CM CLARIFICATION BULLETIN #4

BULLETIN NO:	FOUR (4)	DATE:	February 23, 2024
PROJECT:	SSUSD – ORNAMENTAL FENCE AT FALLER ELEMENTARY SCHOOL		
PROJECT NO:	CCC #23-015		
DISTRICT:	SIERRA SANDS UNIFIED SCHOOL DISTRICT		
ARCHITECT:	ORDIZ-MELBY ARCHITECTS		
CONSTRUCTION MANAGER	COLOMBO CONSTRUCTION CO., INC. 3211 Rio Mirada Drive Bakersfield, CA 93308 661-316-0100	BID DATE:	REVISED February 28, 2024 @ 11 AM

A-121

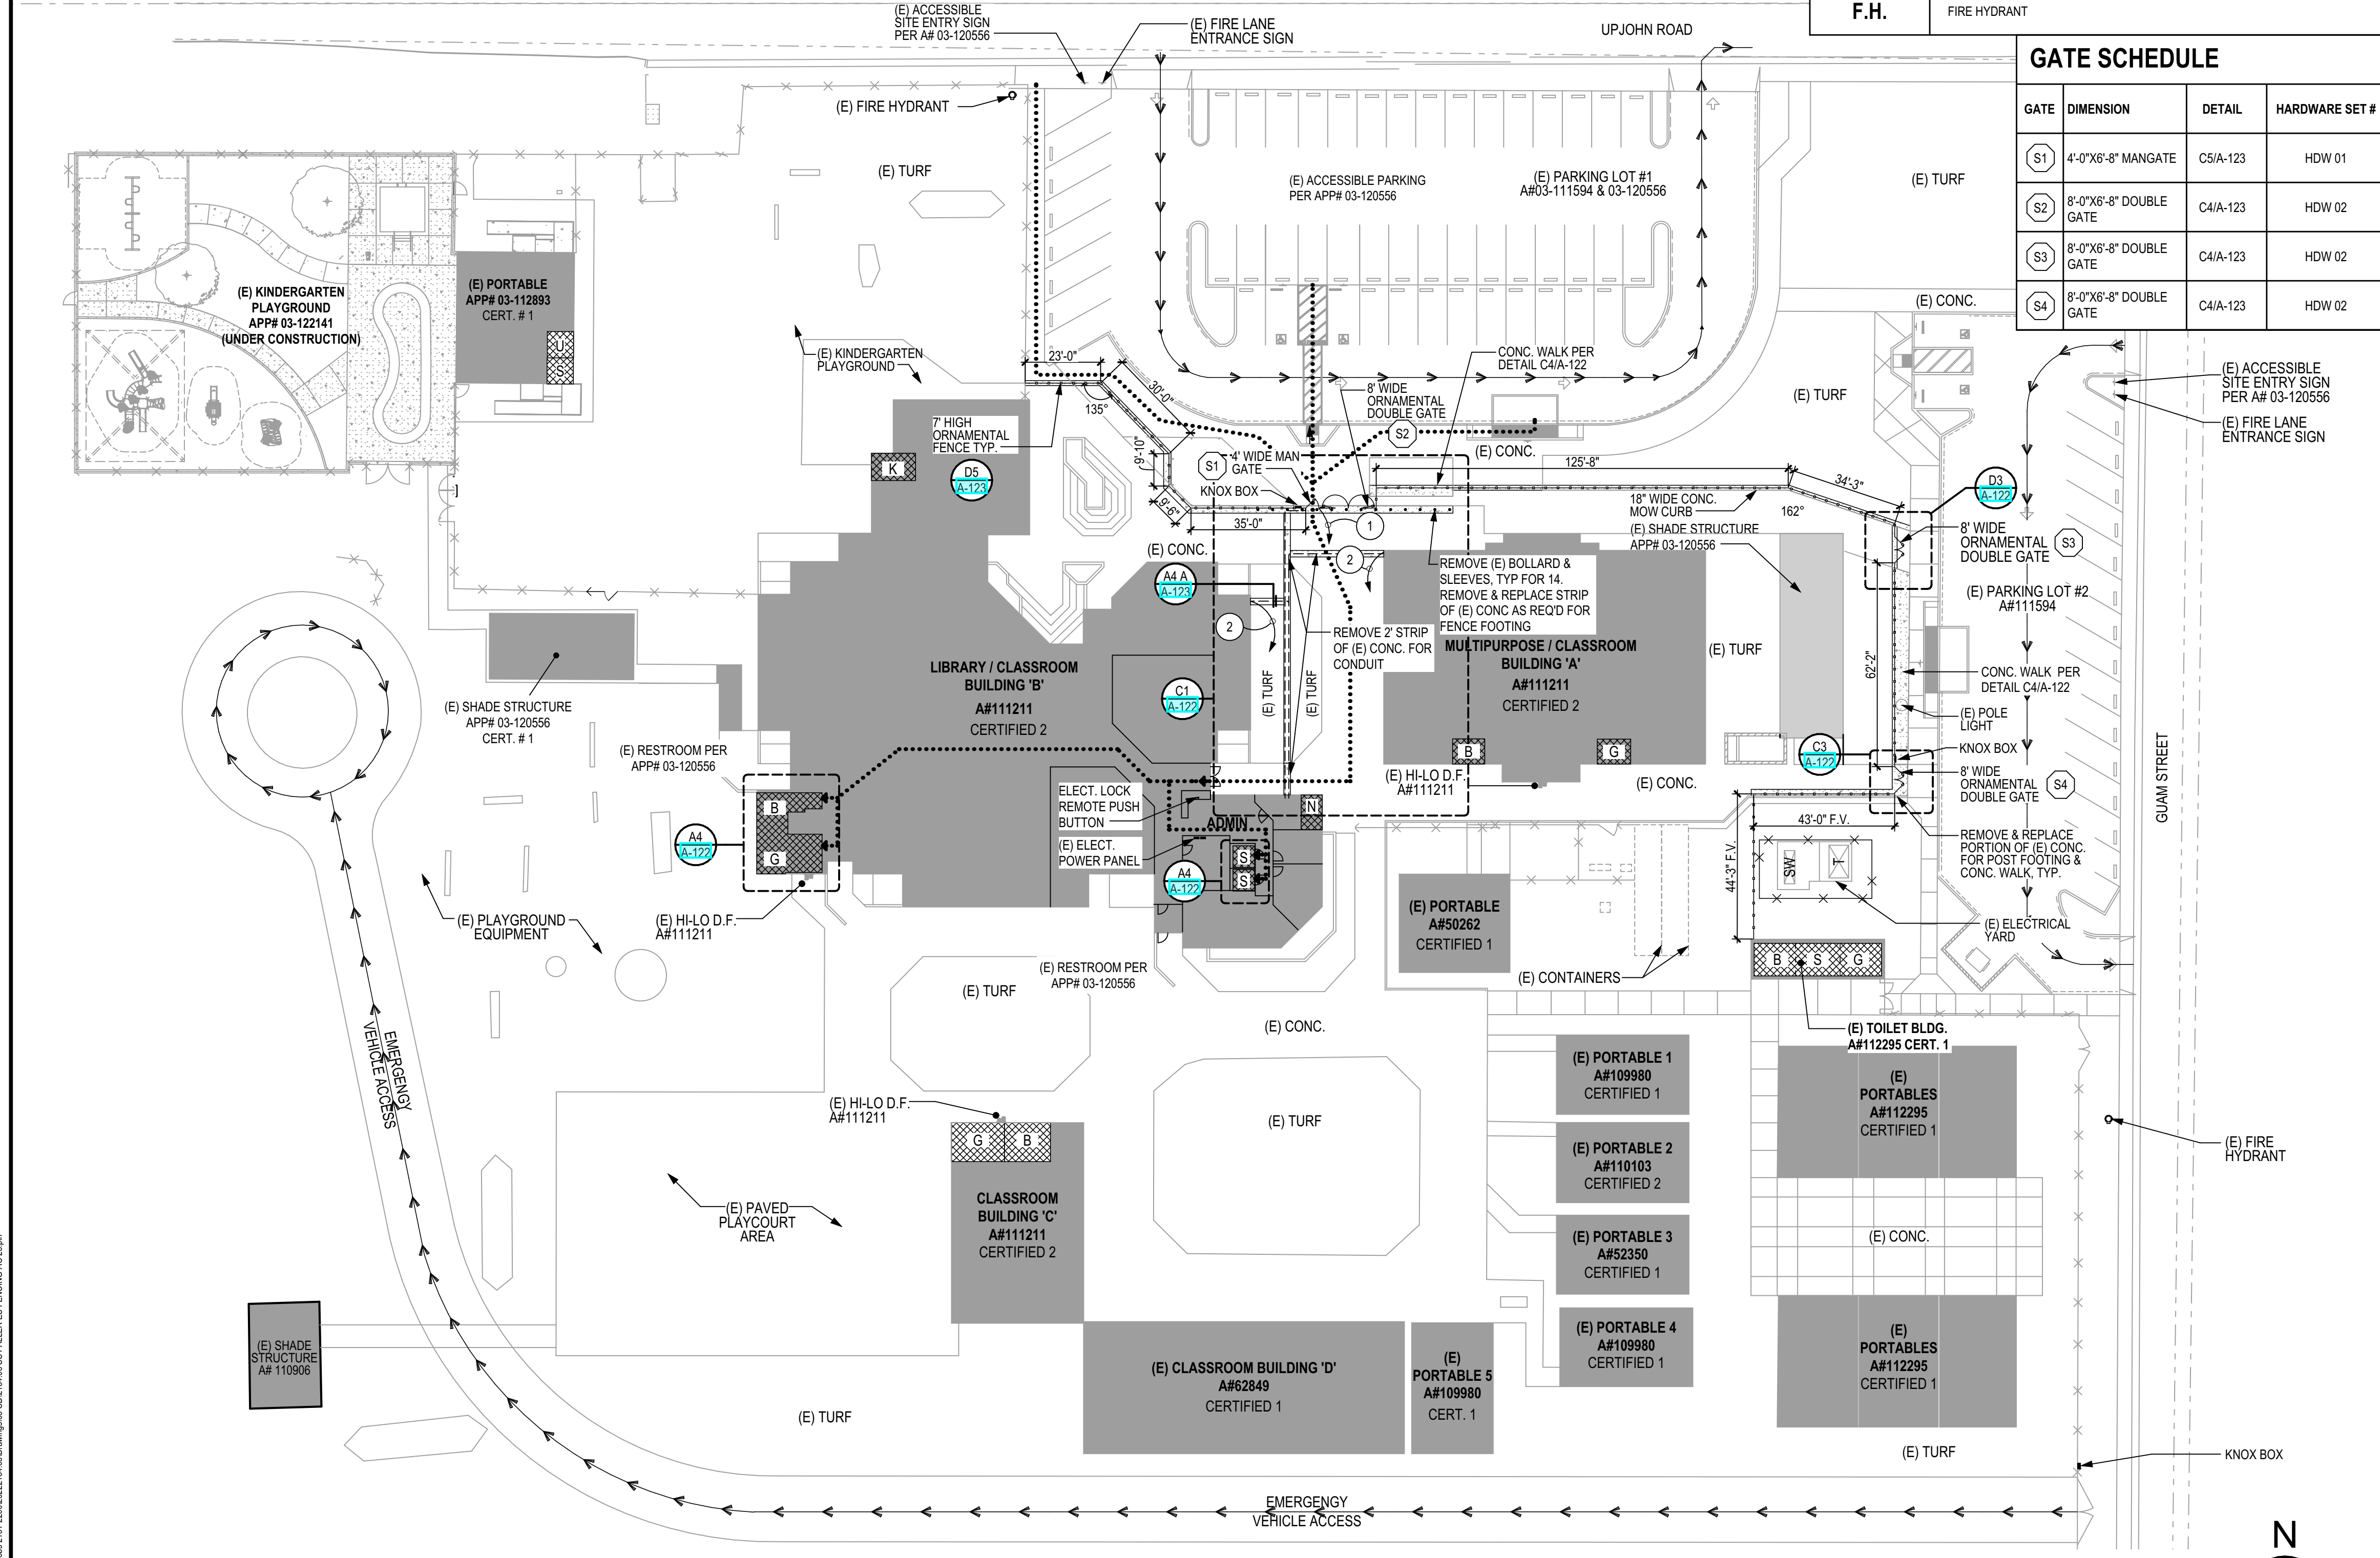
Question	Question from Marisa Garza Colombo Construction Co Inc on Thursday, Feb 1, 2024 at 10:26 AM PST Provide dimension to fence off multipurpose building.
Official Response	Response from Kevin Dunn Colombo Construction Co Inc on Monday, Feb 19, 2024 at 09:58 AM PST The distance from the edge of building to Center line of fence is 19'-0". See attached PDF. Attachments A-121_ OVERALL SITE PLAN Rev.0 markup (1) (1).pdf
